EASTERN CORRIDOR SEGMENTS II AND III (PID 86462)

VILLAGE OF NEWTOWN FOCUS AREA

ADVISORY COMMITTEE MEETING NOTES

MEETING #4 NOTES

**Shared-Use Path Along
Round Bottom and Valley**

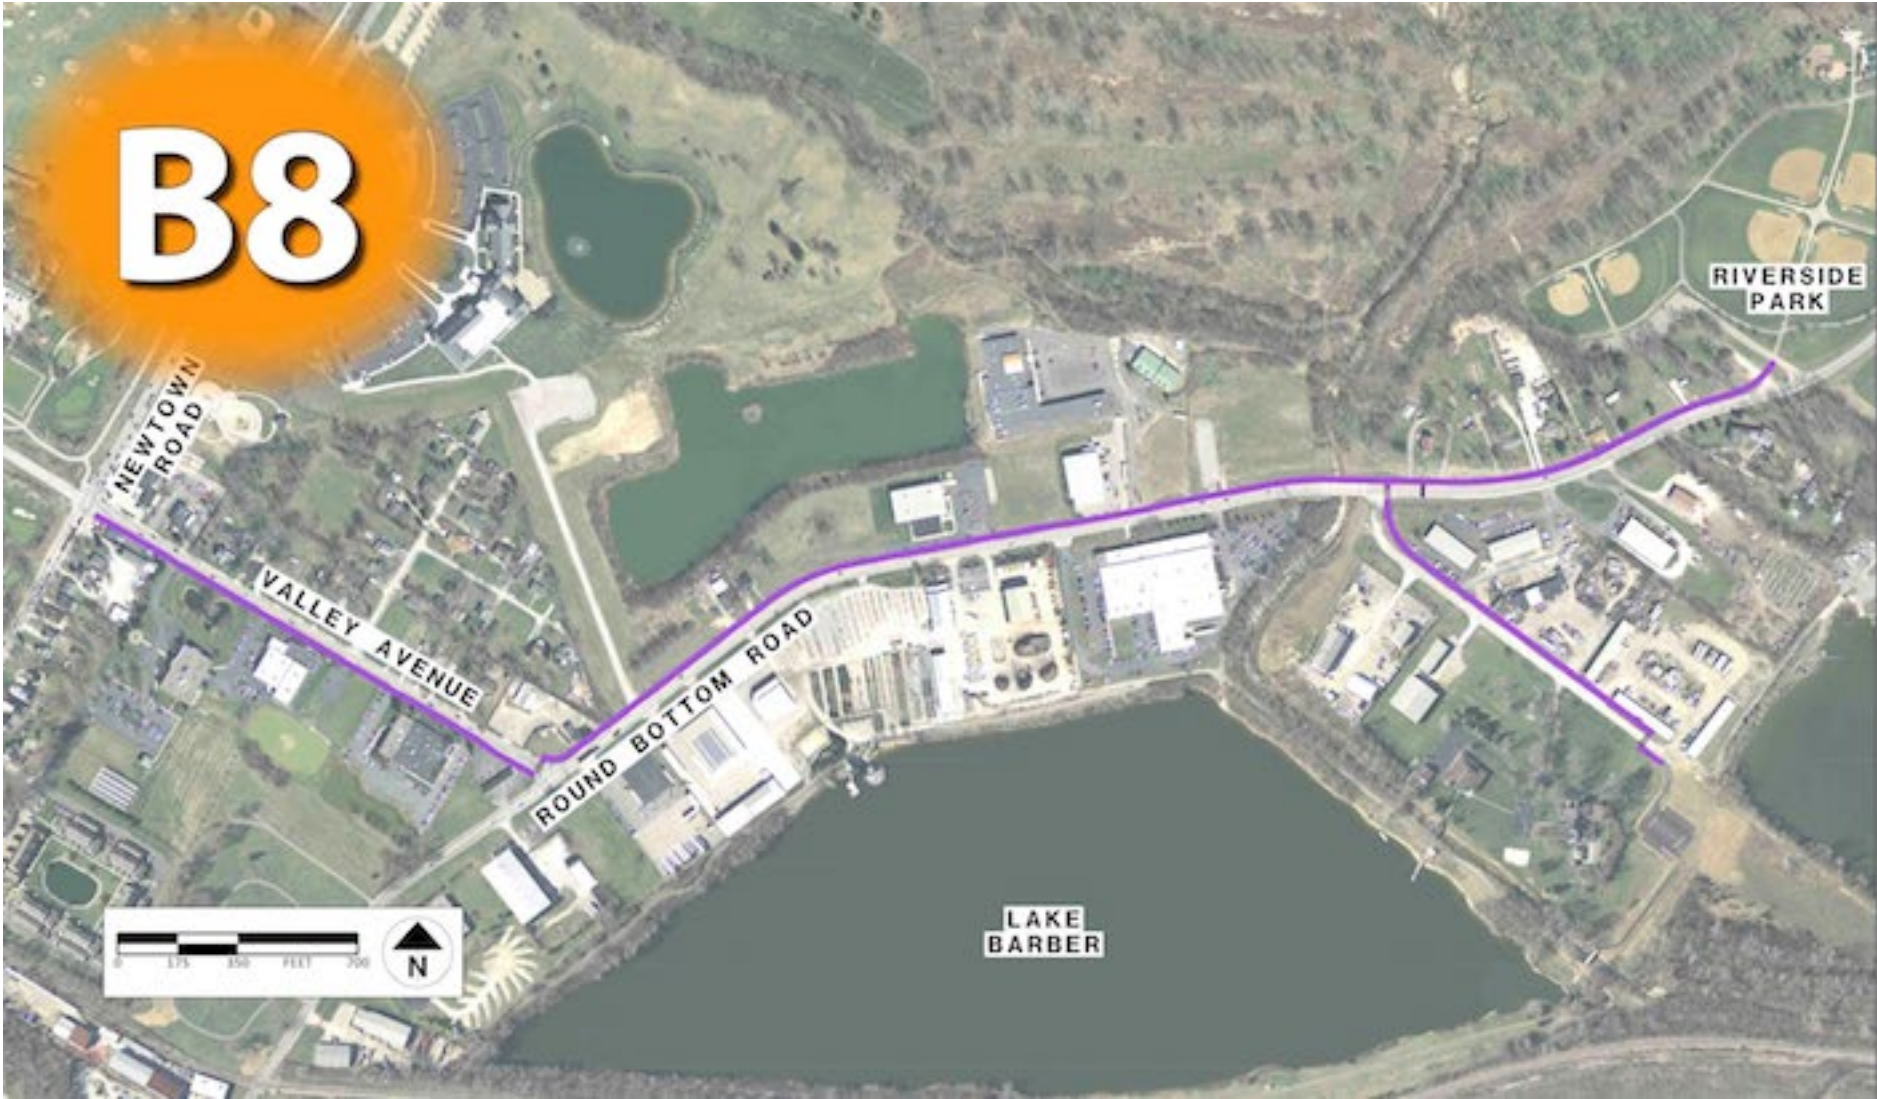
- Add a sidewalk along Round Bottom Road to Valley Avenue.
- ODOT looked at a shared-use path but there are a few constraints that limited opportunity, such as limited space along the front of the Hamilton County Engineer’s garage on the east side of the road and the Flag Spring Cemetery on the west side.
- Perhaps the Hamilton County Transportation Improvement District can assist with this project.
- No additional comments were received following the 9/6 meeting.

- The concept would be adjusted to extend just between the railroad and Valley. The section extending between SR 32 and the railroad would then be added to concept I-5a (B2).
- The Sierra Club stated that if it will take a longer period of time to further develop and implement the roadway portions of these projects, it hopes that shared-use paths would still be completed in the nearer-term.

- Include the section between SR 32 and the railroad in concept I-5a (B2) in the Implementation Plan and advance as a high priority.
- Add shared-use path between railroad and Valley as a medium priority.

- Separate this concept into individual segments to allow the Village of Newtown more flexibility to determine priorities. The path along Round Bottom from Valley Avenue to Riverside Park will go back to concept RB-1. The path along Valley Avenue will remain concept RB-3a (B8) and both will be included in the Implementation Plan as medium priorities.
- Village of Newtown to work with its constituents as part of its Master Plan Update to determine which segments of the two concepts [RB-3a (B8) or RB-3d (B10)] should be advanced for implementation.

**Shared-Use Path Along
River Connecting at Bass
Island Access**

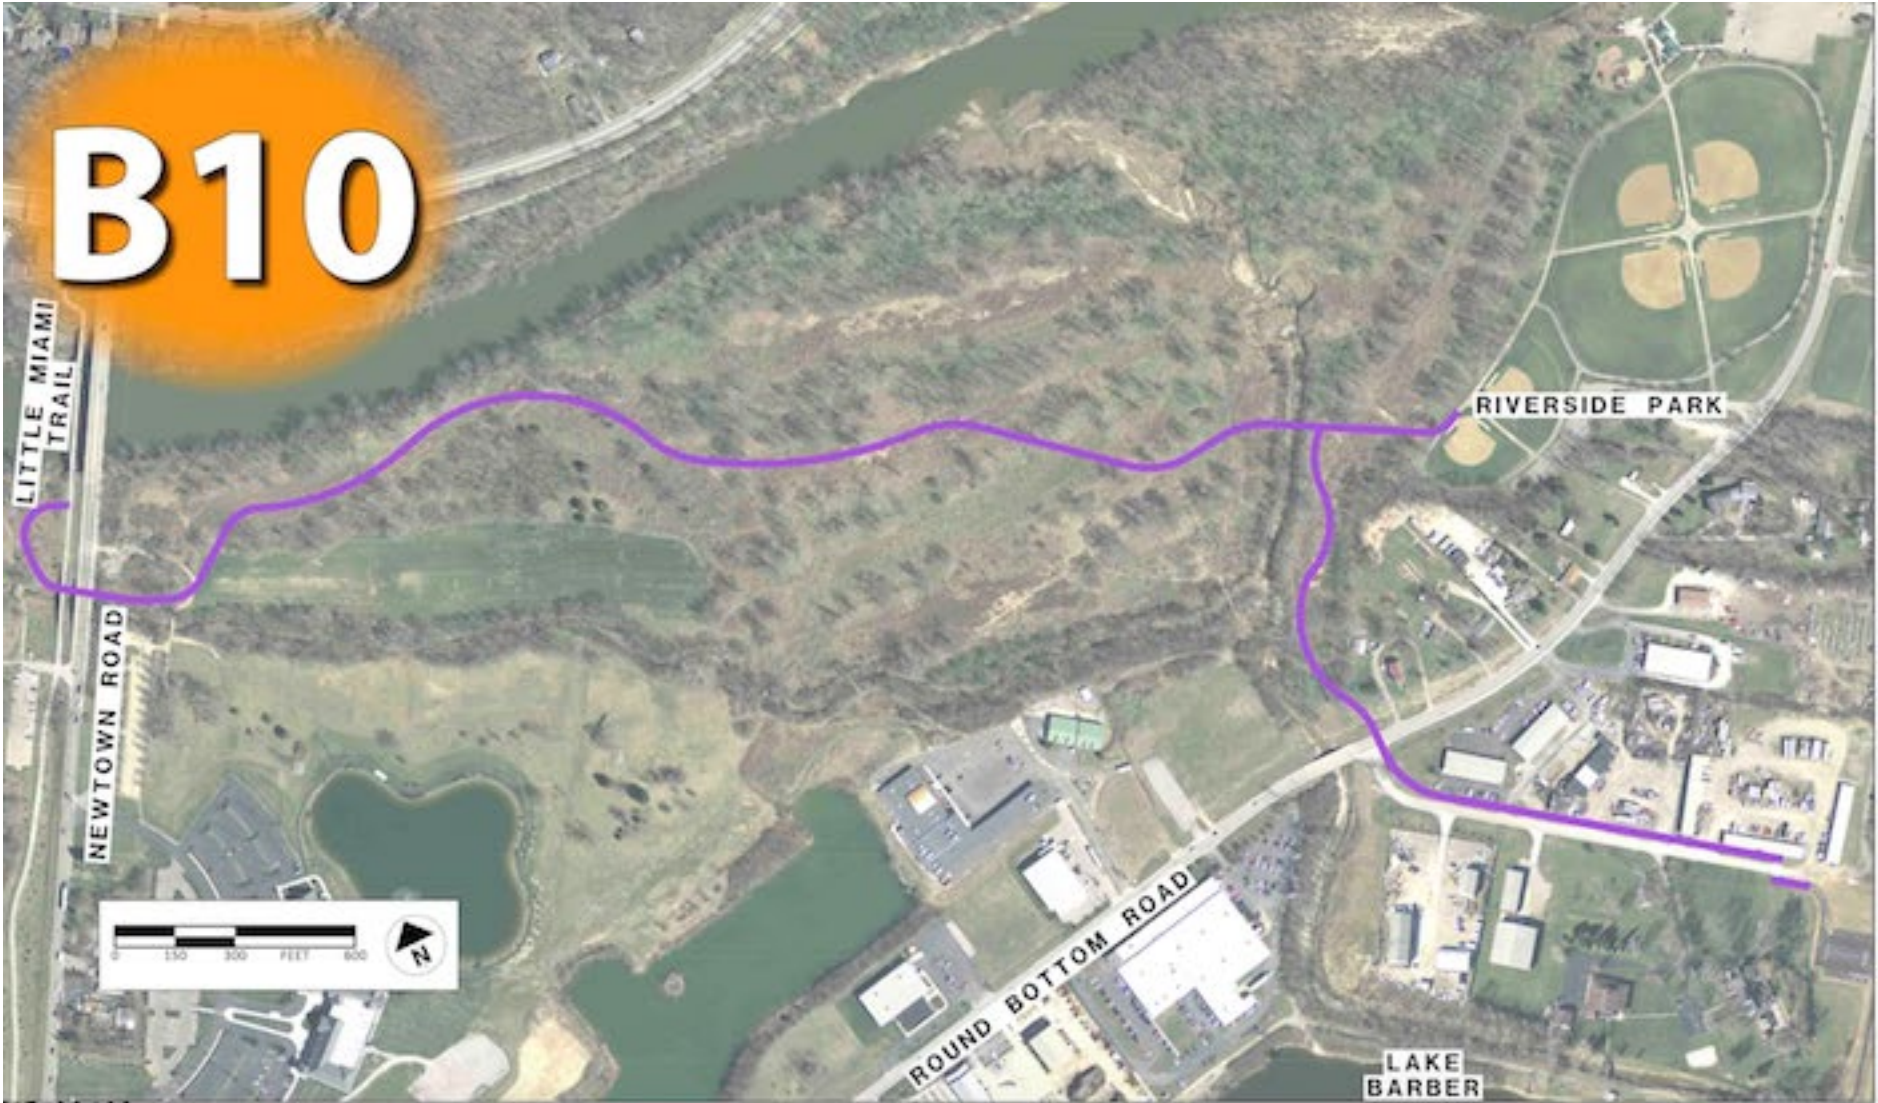
- This trail alternative would begin approximately 500 ft north of the Bass Island Trailhead, turn immediately south and travel under Newtown Road using an existing structure, cross through the former golf course (now owned by Great Parks of Hamilton County) and across a creek, and end at Riverside Park. A short trail spur beginning after the creek crossing would connect RB-3c to Lake Barber.
- RB-3c seems to be preferable compared to RB-3d (costs less, less impact to park space).
 - RB-3d would require a higher level environmental assessment document (level D1 vs. C2).
- No additional comments were received following the 9/6 meeting.

- Include concept in the Implementation Plan as a medium priority.
- Village of Newtown to work with its constituents as part of its Master Plan Update to determine which segments of the two concepts [RB-3a (B8) or RB-3d (B10)] should be advanced for implementation.
